PILGRIM NUCLEAR POWER STATION

AMENDMENT TO FACILITY OPERATING LICENSE

Amendment No. 88  
License No. DPR-35

SAFETY EVALUATION BY THE OFFICE OF NUCLEAR REACTOR REGULATION  
SUPPORTING AMENDMENT NO. 88 TO FACILITY OPERATING LICENSE NO. DPR-35  
BOSTON EDISON COMPANY  
PILGRIM NUCLEAR POWER STATION  
DOCKET NO. 50-293

Figure 6.2.1

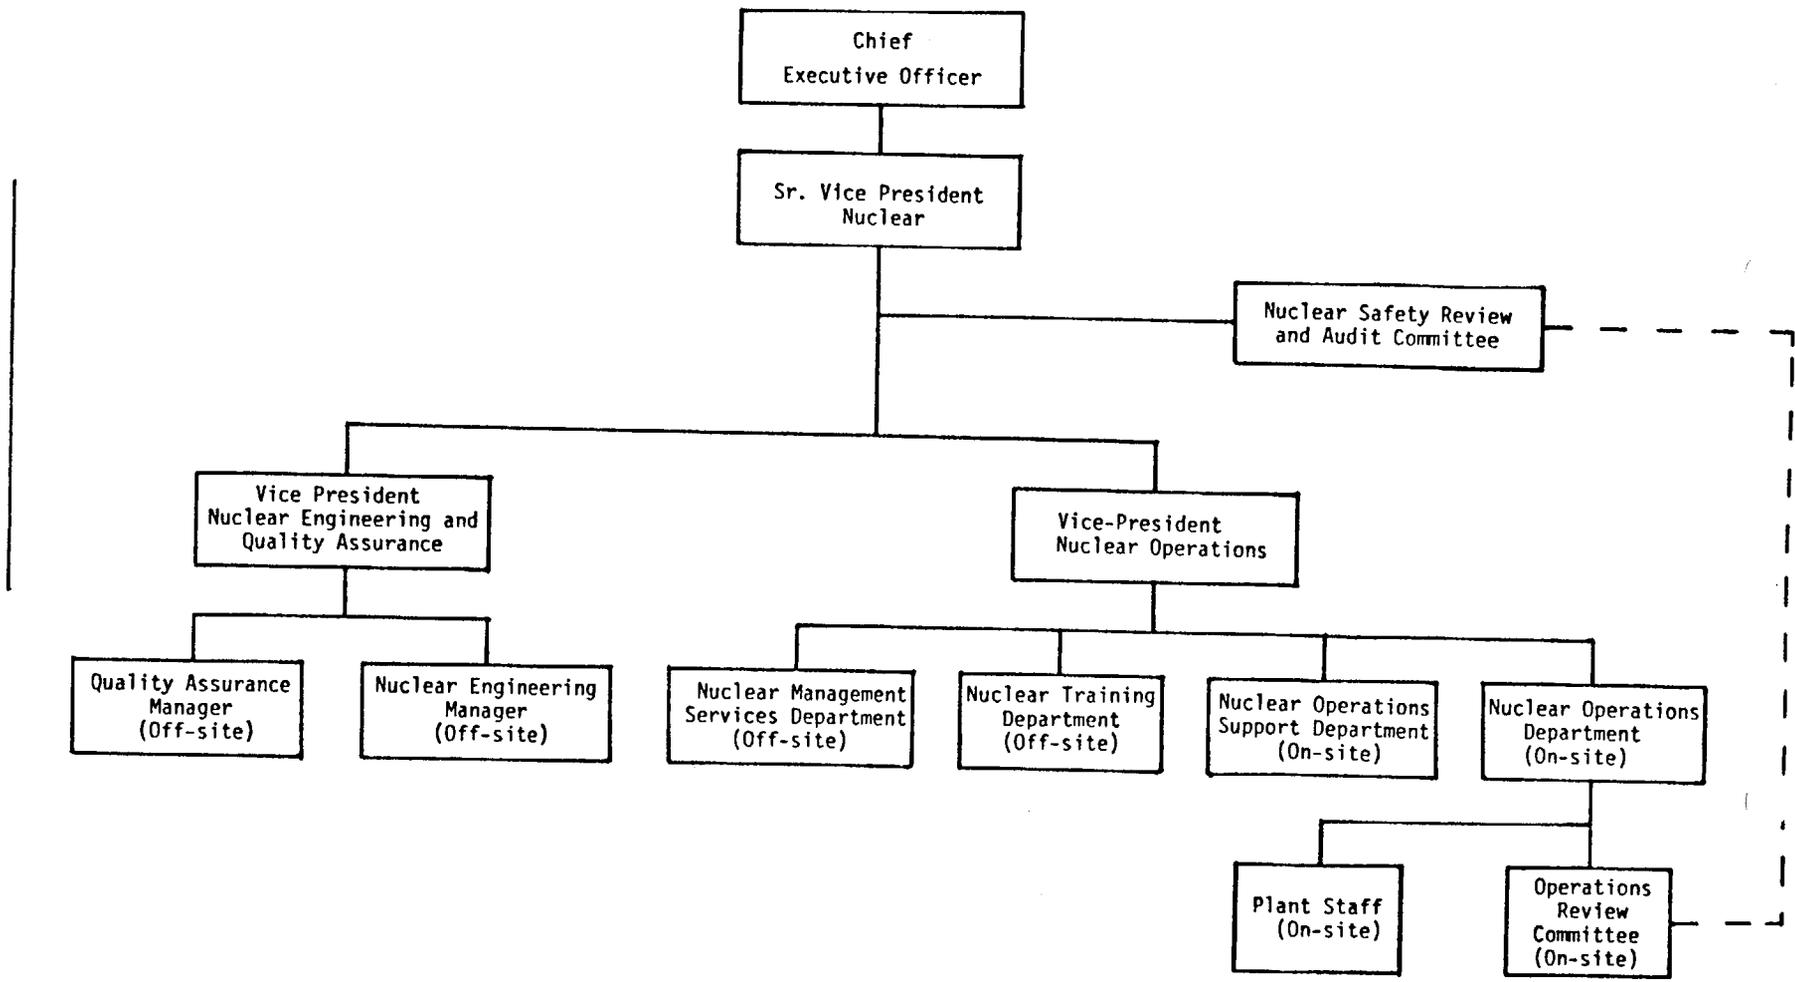
5. Section 6.2.A - BECo has revised the company organization under the Senior Vice President Nuclear by deleting the functions of the Director of Operations Review and the On-Site Safety and Performance Group Leader. The staff previously reporting to On-Site Safety & Performance Group Leader has been transferred to the Nuclear Operations Manager (see item 7 below). We find these changes acceptable as other organizational changes have obviated the need for these positions (see letter dated December 30, 1983, from William P. Harrington, BECo to Dr. Thomas E. Murley, NRC Region I).

The Company organization for station management and technical support shall be as shown on Figure 6.2.1.

Figure 6.2.2

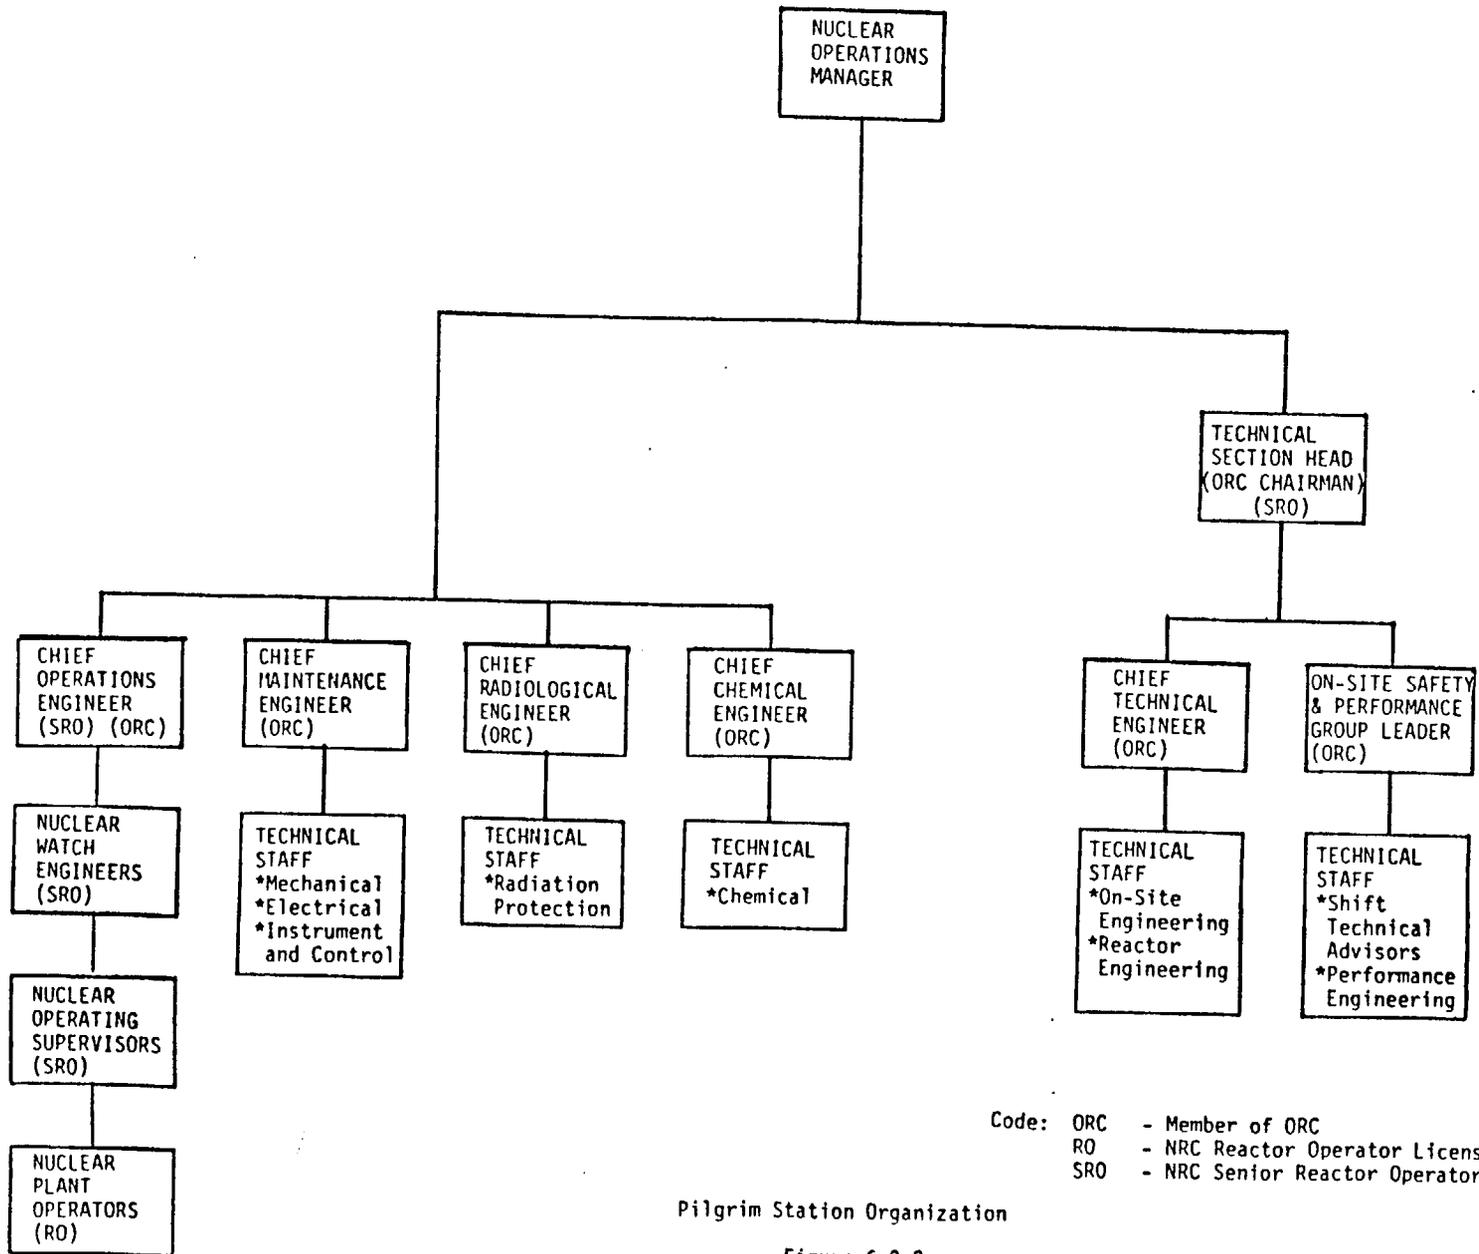
6. Section 6.2.B - BECo has revised the Pilgrim Station Organization by establishing the new positions of Technical Section Head, to whom the Chief Technical Engineer and the On-Site Safety and Performance Group Leader now report, and of Chief Chemical Engineer. The Technical Section Head and the Chief Chemical Engineer report to the Nuclear Operations Manager. Figure 6.2.2 shows these changes and we find them acceptable.

The Facility organization shall be as shown on Figure 6.2.2 and:
